ADDENDUM NO. 2
(4 Pages of text, 10 pages of attachments / Total = 14 Pages)

TO THE DRAWINGS, SPECIFICATIONS AND CONTRACT DOCUMENTS FOR:

Fairfield County
Sheridan Center Renovations - Phase1
Comm. No. 2024149.01

1 FIRST FLOOR PLUMBING PLAN
P100 1/8" = 1'-0"

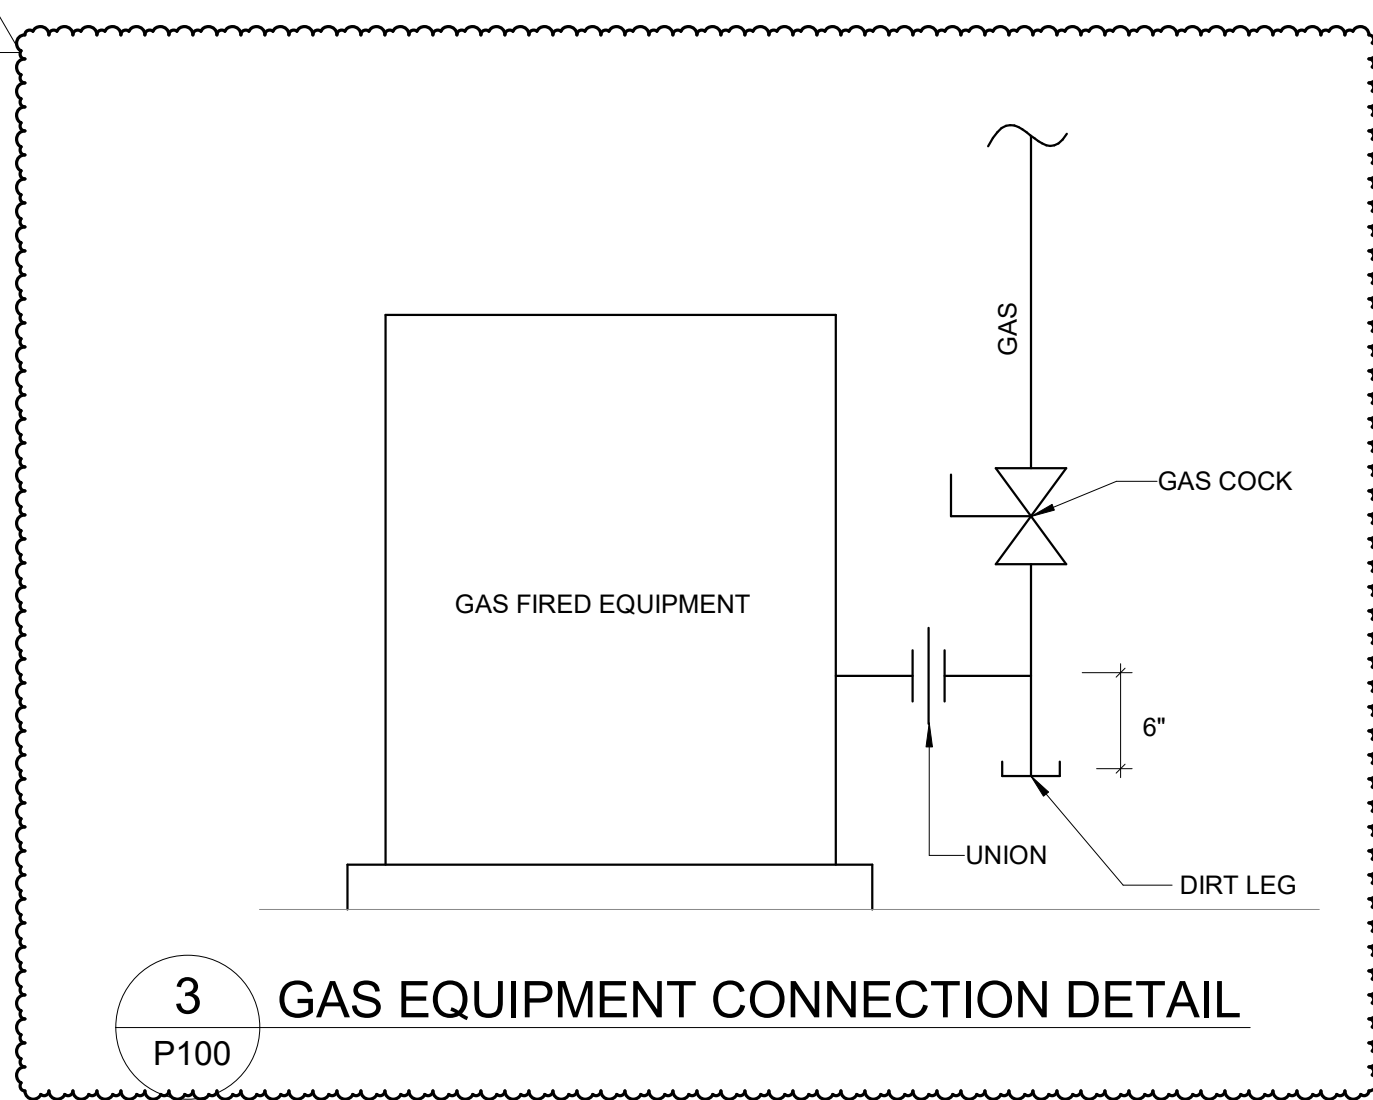
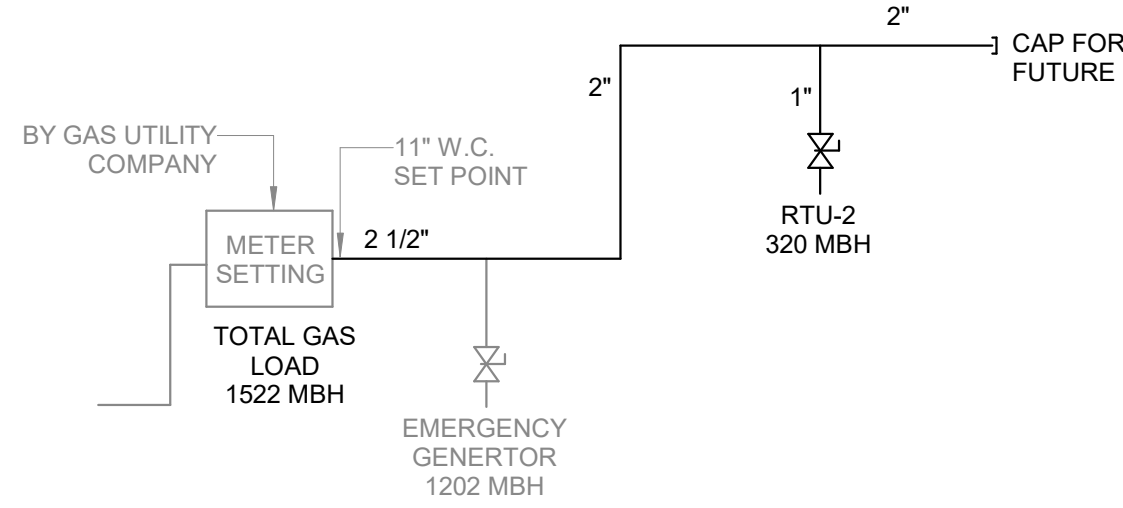
- B. Remove Keynote PD11 and replace with PD3
- 4. **SHEET P100 – Plumbing First Floor Plan (Re-Issued):**
 - A. Plumbing Roof Plan View 2/P100 added to show gas pipe scope.

- B. Gas Equipment Connection Detail View 3/P100 added.
 - C. Gas Piping Schematic View 4/P100 added.
 - D. Keynotes P24 and P68 added.
 - E. 2" vent pipe added to MB-1 located in 1112 Storage.

- F. Locations to underground sanitary tie in points have been modified.
 - G. Remove new floor drain for 1104 AV Room
- 5. **SHEET P400 – Plumbing Isometrics (Re-Issued):**

1 WASTE AND VENT ISOMETRIC
P400

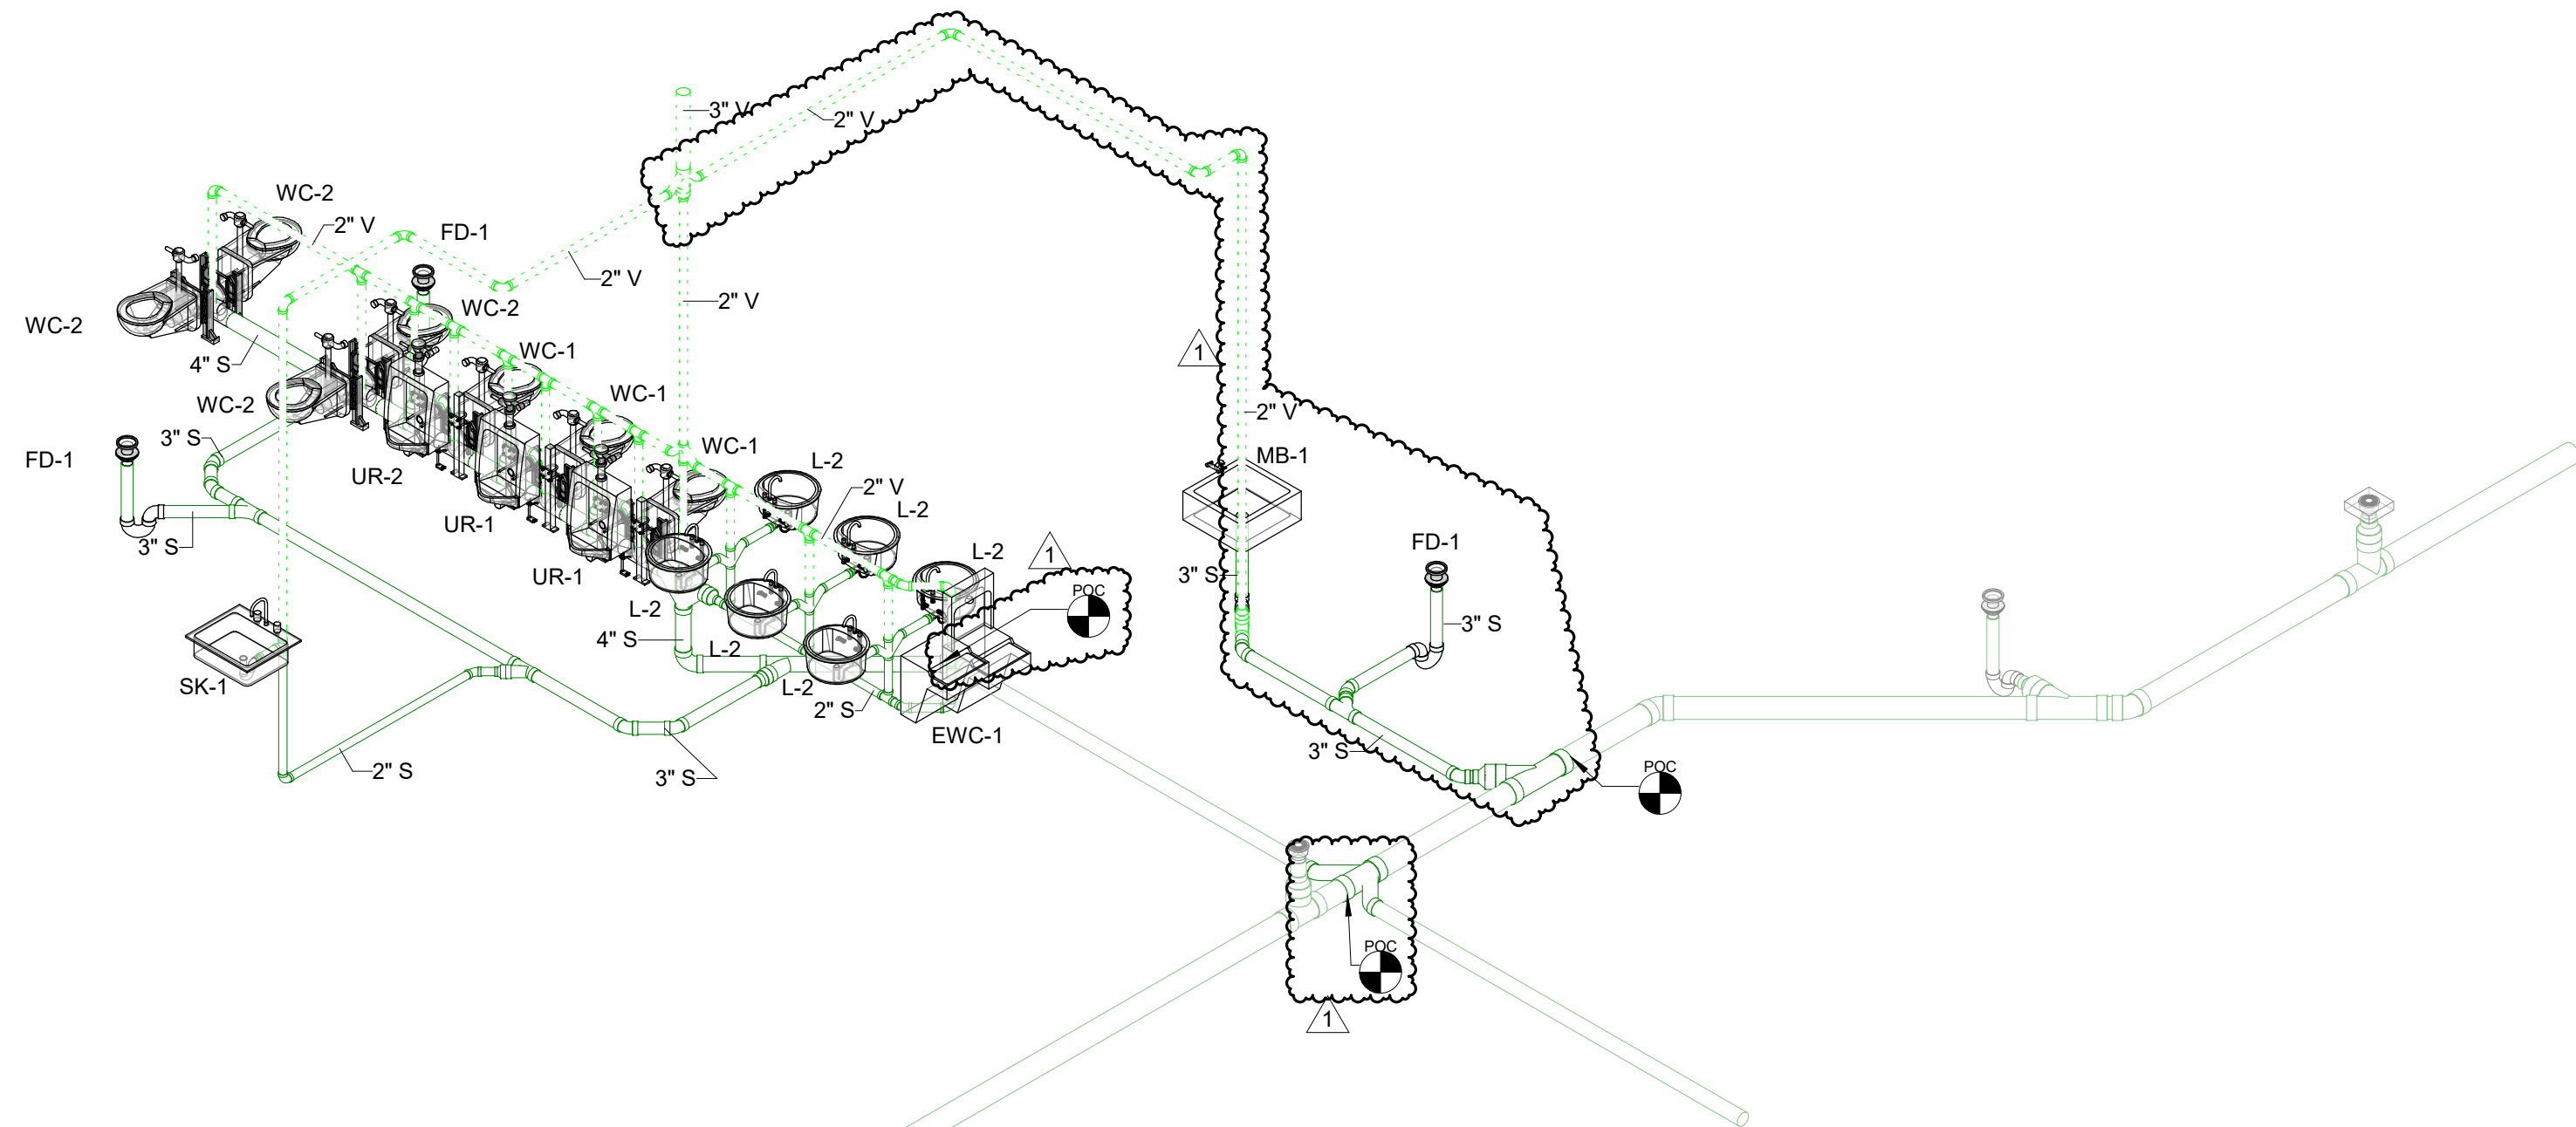
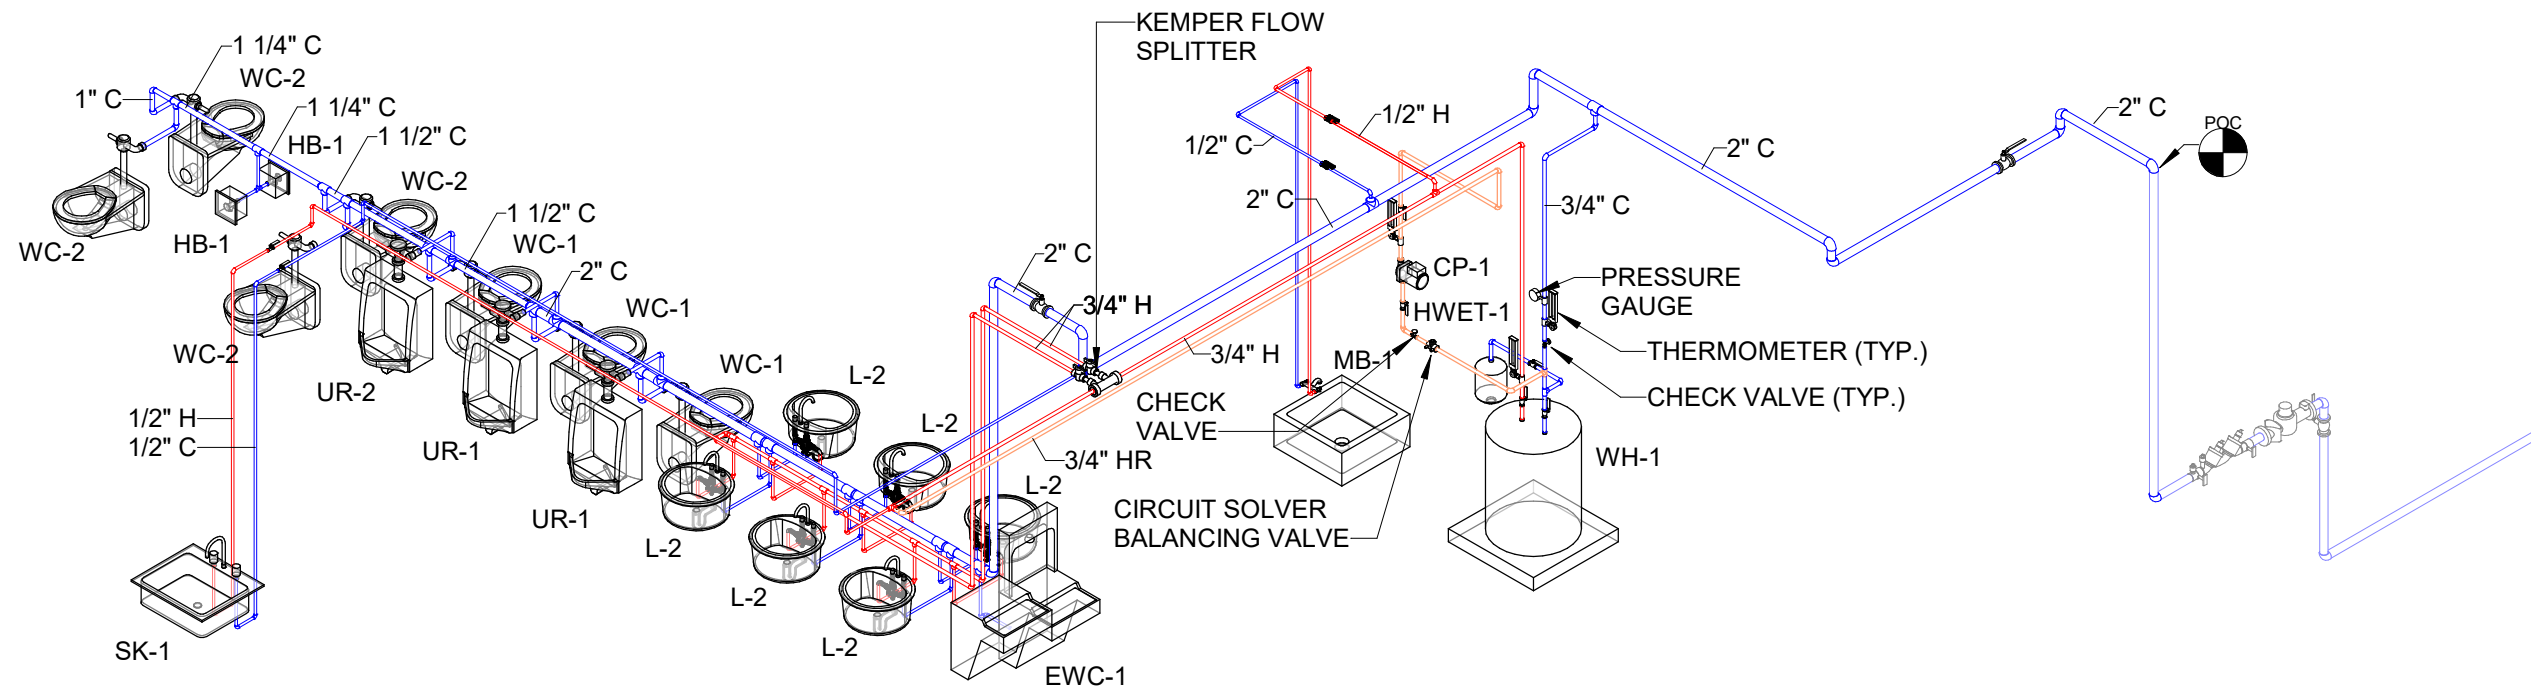
- A. Waste and Vent Isometric revised to show new plumbing vent and underground sanitary tie in points
 - B. Remove new floor drain for 1104 AV Room
- 6. **SHEET E001 – Electrical Legends (Re-Issued):**

E011

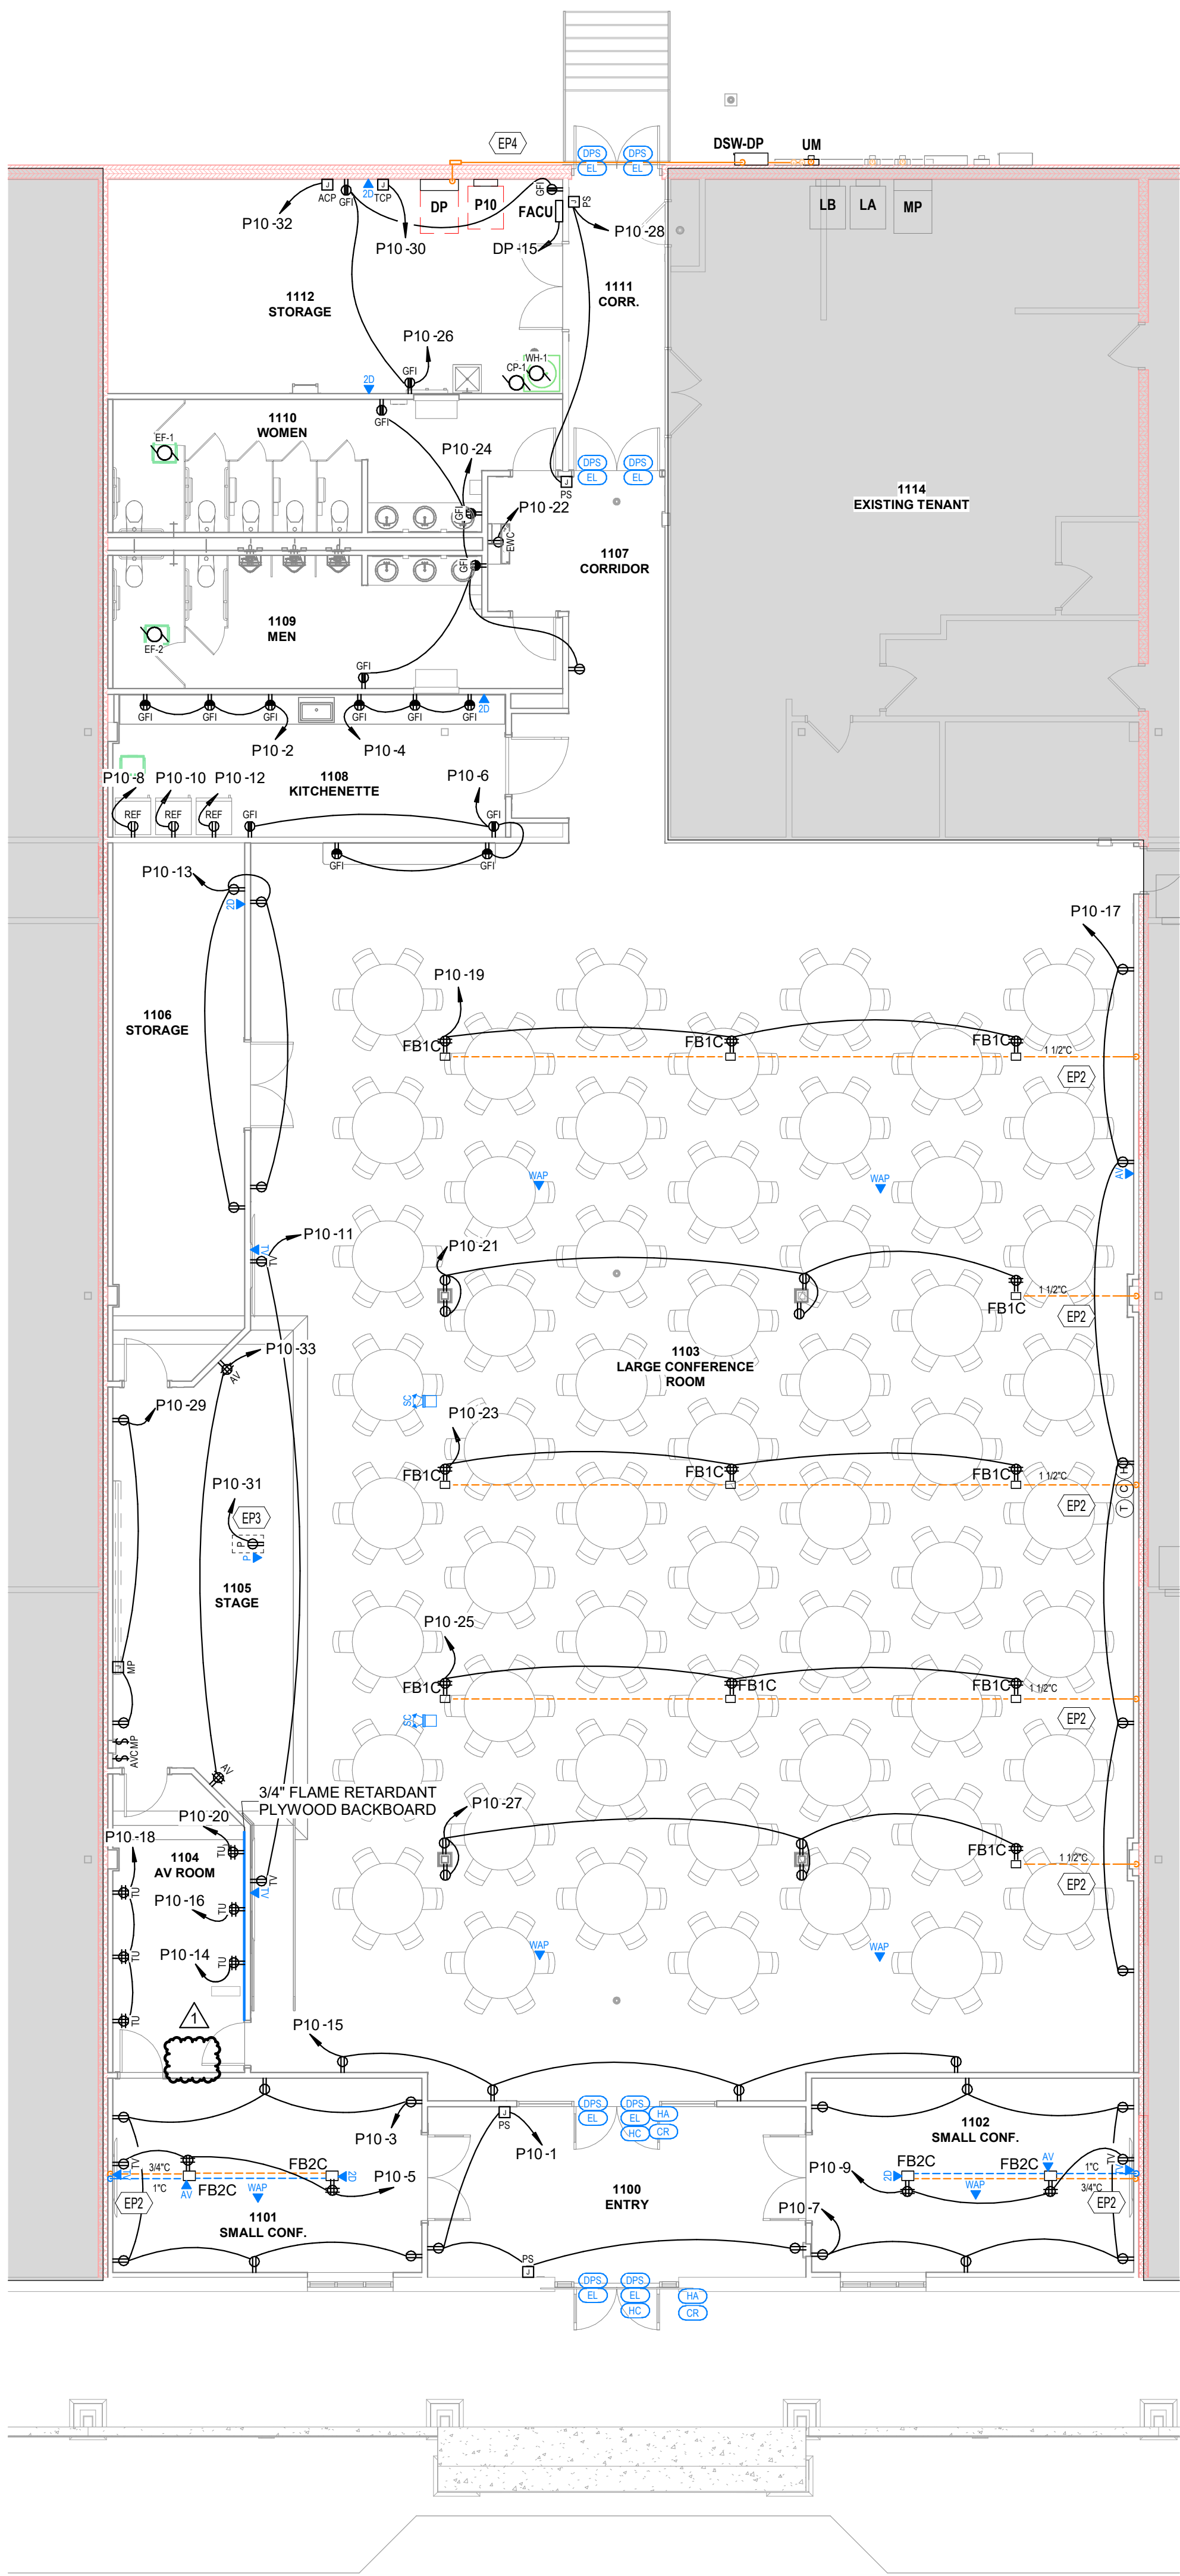
- D. Revised Mechanical Equipment schedule with updated RTU-4 information.
 - E. Removed ductless split unit from schedule.
- 7. **SHEET E011 – Electrical Demolition Plans (Re-Issued):**

- A. Revised roof demolition plan for clarity of demolished mechanical units.
 - B. Added keynotes ED7, ED8, ED9.
- 8. **SHEET E201 – Electrical Power Plans (Re-Issued):**
